MIDWAY MFG. CO.

TABLE OF CONTENTS

S E R V I C E B U L L E T I N

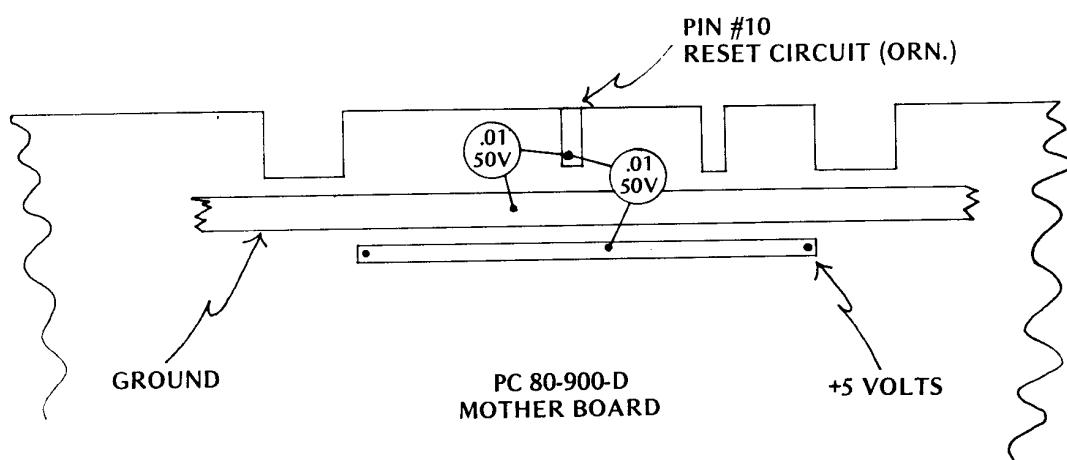
CONDITION: Random errors appearing on TV screen.

MODIFICATION: Add two .01 MFD capacitors to the mother board, PC 80-900; reset circuit (CPU) as shown below.
